ADDENDUM #3

Solicitation Number: 20-1207

Title: Conference Room Renovations-Building 59, CEF, Ottawa

Date: January 21st, 2021

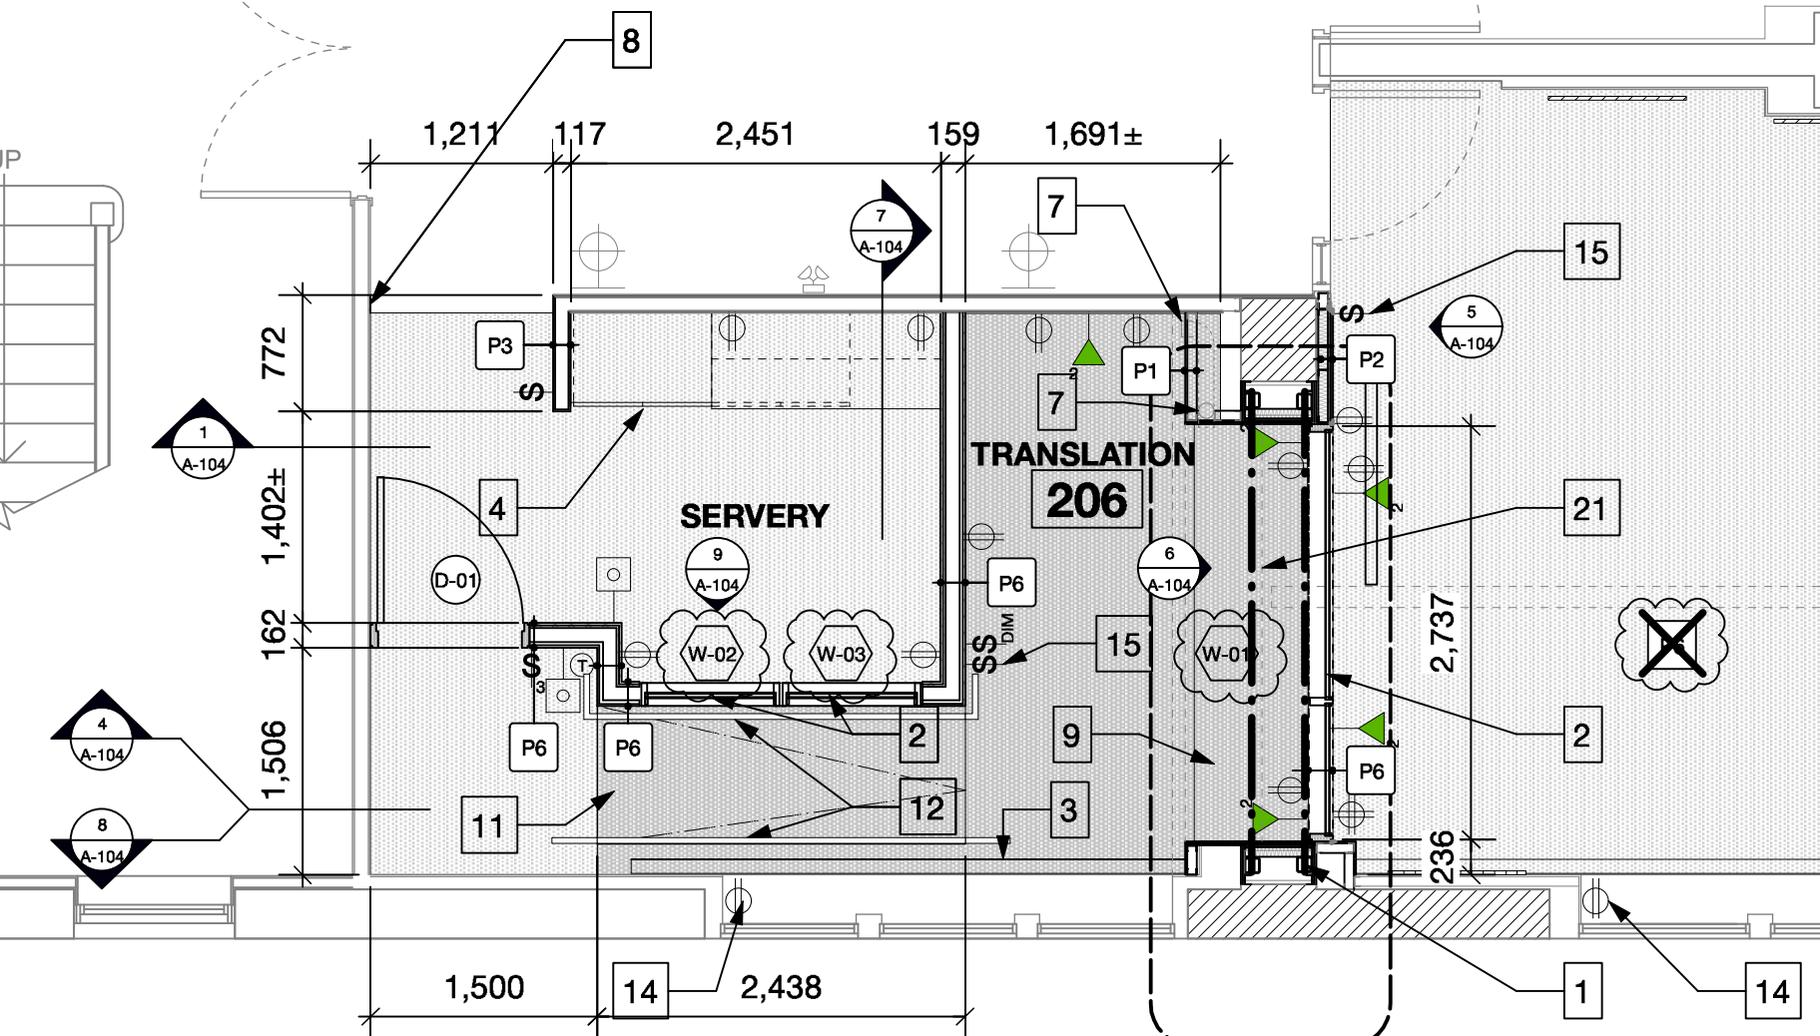
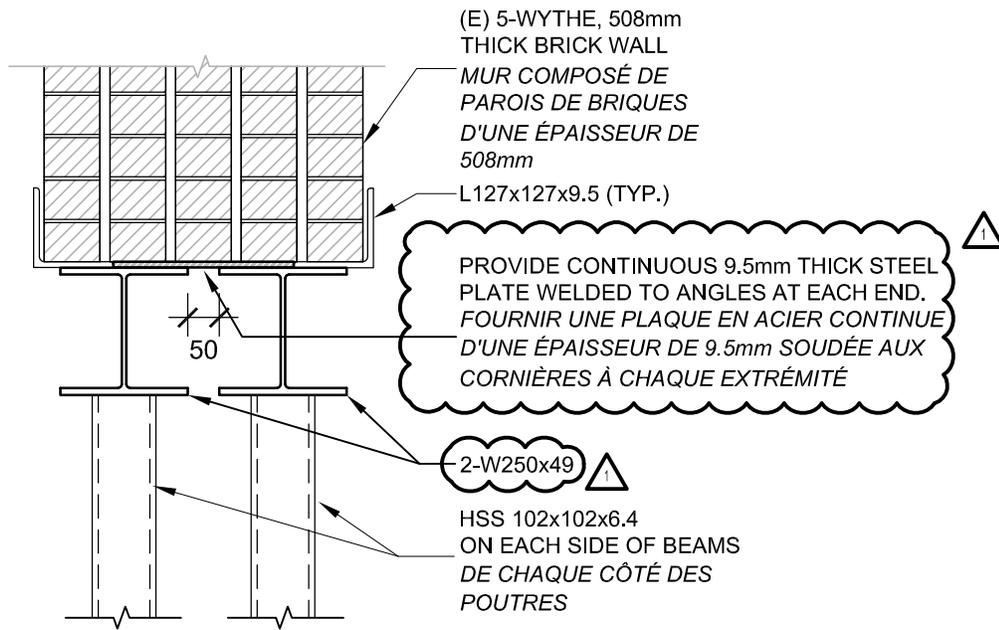
Q 25. The door schedule spec's a pneumatic door operator complete with compressor with electric strike relay, tubing and actuators. The model is based on an LCN 4660 which in fact is not a pneumatic door operator. My question is, does the door operator have to be pneumatic operated? My second question... is the operator to be installed on the push or pull side of the opening (door D-01)?

A 25. Revise Specifications Section 08 71 00 (Door Hardware),
3.06 Schedule,
.1 Hardware Group 1: (Door D-01),
.3 1 Barrier-free pneumatic door operator

Delete: "Basis of Design: LCN 4660"

Insert / Replace with: "Basis of Design: LCN 4820"

The door operator should be pneumatically operated. The door operator was specified as a pneumatic operator in order to provide the quietest operation.
The operator is to be installed on the push side.
